July 2016

SEPP65 – AMENDED DESIGN VERIFICATION STATEMENT FOR DEVELOPMENT APPLICATION FOR A MIXED USE DEVELOPMENT AT 229 MILLER STREET NORTH SYDNEY

**RE: DA 487/15 229 Miller Street, North Sydney\
Amended Architectural Plans – DA 01 to DA 62 - all Dated 14 July 2016
JRPP 2016SYE015**

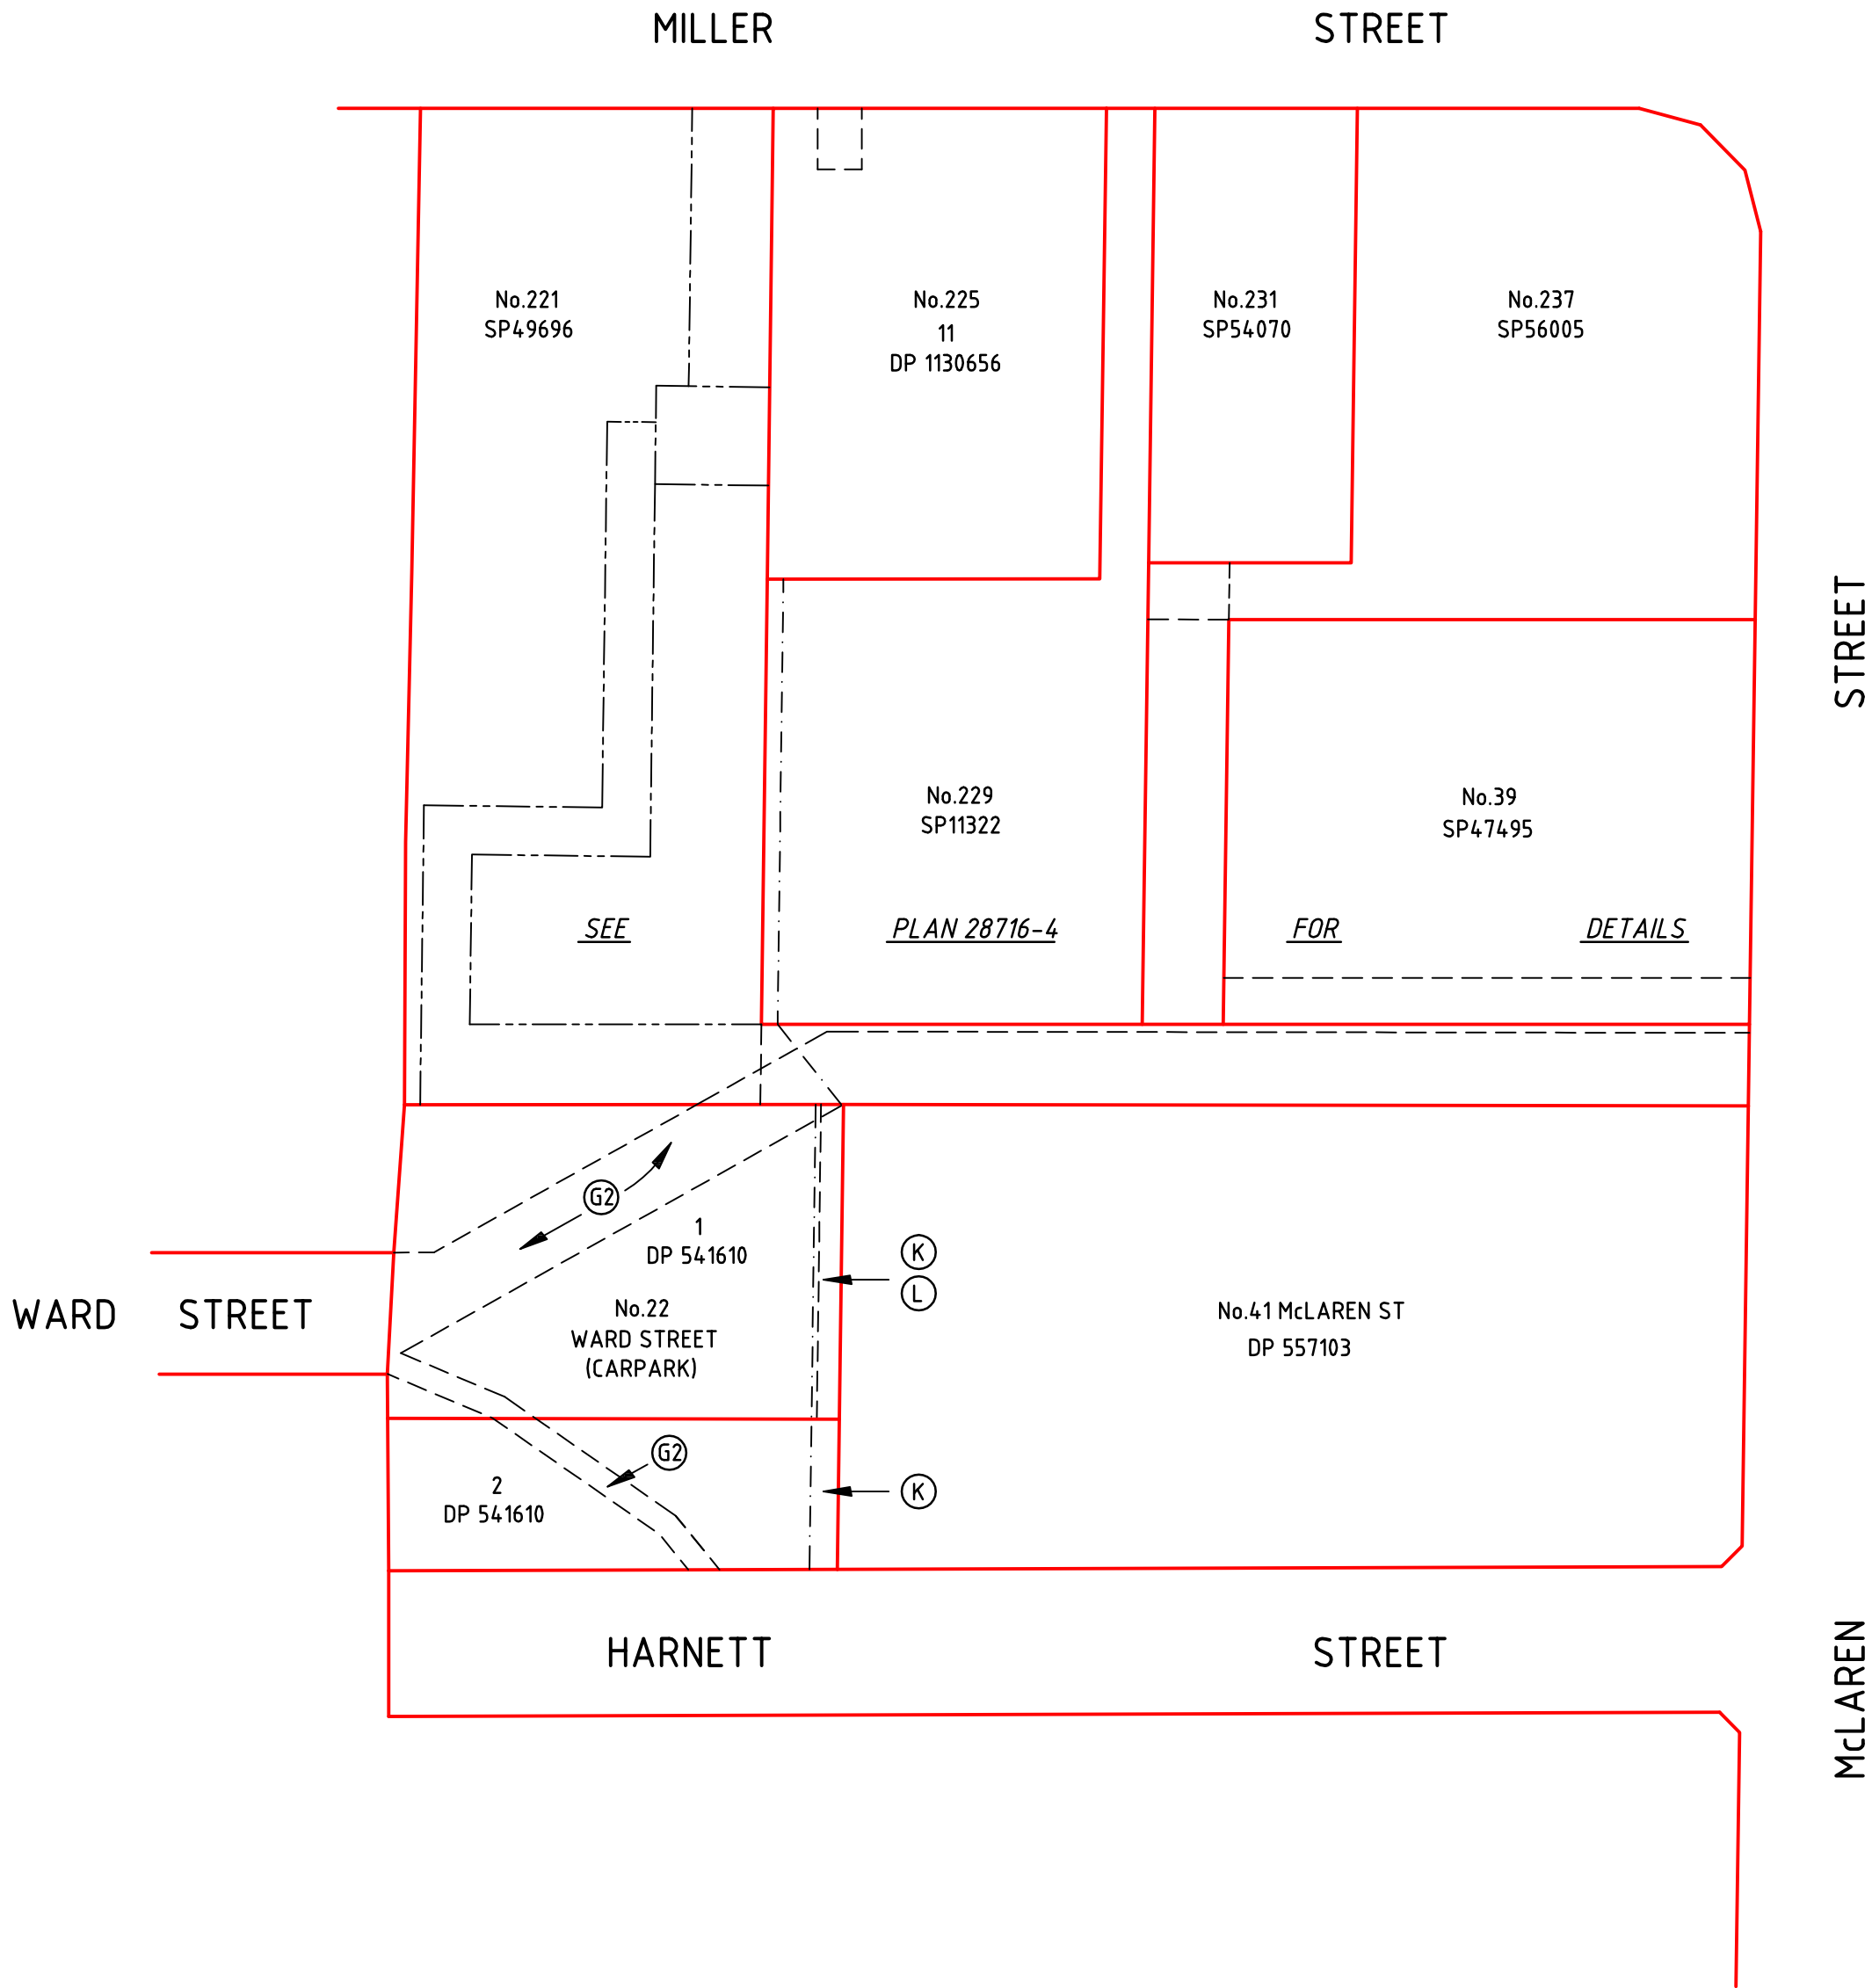
As discussed in our last meeting, we have had further discussions with our surveyor (Chris Norton) regarding what happens to the stormwater pipes from the pit located next to the eastern boundary of our site.

Chris has updated the attached PDF showing the easements after that point (page 2 in particular).
